Access Compliance Report

Public Rights-of-Way

Intersection ID: N/A	Main Street: LANGWELL_LN	Cross Street: HAMILTON_BRIDGE_RD	Location: SW
ADA ID: 13FB09D8F4A0	Ramp Type: Perp	Initial Pass/Fail: Fail	Overall Compliance: No
Severity Score: 22.5			
Codes/Mitigation Info/Possible Solution		Field Measurements/Component Compliance

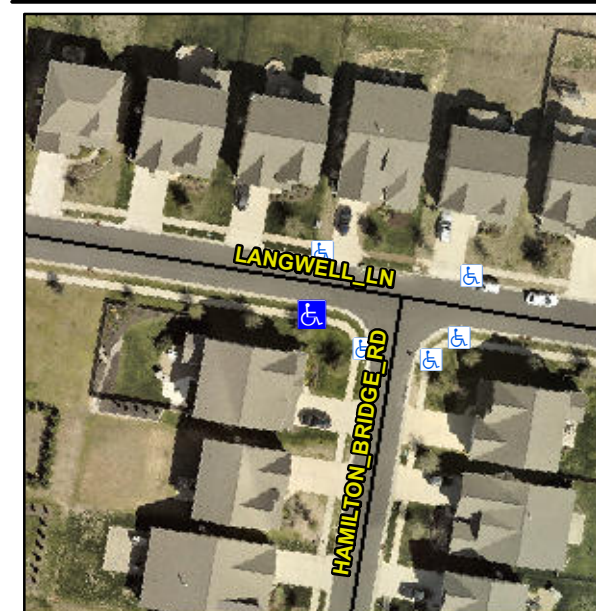
Not Found, R304.5.1, R304.2.2, R304.5.3

Compliance	Description	Data	Compliance	Description	Data
N/A	Ramp Length (in)	48.0	No	Ramp Slope (%)	10.1
No	Ramp Width (in)	46.5	No	Ramp XSlope (%)	2.2
N/A	Flare Type LT	N/A	N/A	Flare Type RT	N/A
N/A	Flare Slope LT (%)	N/A	N/A	Flare Slope RT (%)	N/A
N/A	Flare Traversable LT?	N/A	N/A	Flare Traversable RT?	N/A
N/A	Landing Length (in)	N/A	N/A	DWS Provided?	N/A
N/A	Landing Width (in)	N/A	N/A	DWS Contrast?	N/A
N/A	Landing Slope (%)	N/A	N/A	DWS Length (in)	N/A
N/A	Landing X Slope (%)	N/A	N/A	DWS Full Width?	N/A
N/A	Landing Curb? (Y/N)	N/A	N/A	DWS Offset (in)	N/A
N/A	Shared Landing?	N/A			
N/A	Gutter Ponding?	N/A	N/A	Gutter Slope (%)	N/A
N/A	Gutter Lip Ht (in)	1.0	N/A	Gutter X Slope (%)	N/A
N/A	Painted X Walk1?	No	N/A	Painted X Walk2?	N/A
	X Walk 1 Direction	To NE		X Walk 2 Direction	N/A
N/A	X Walk 1 Width (in)	N/A	N/A	X Walk 2 Width (in)	N/A
	X Walk 1 Slope (%)	0.3		X Walk 2 Slope (%)	N/A
	X Walk 1 X Slope (%)	2.0		X Walk 2 X Slope (%)	N/A

Remove & Replace Entire Ramp.
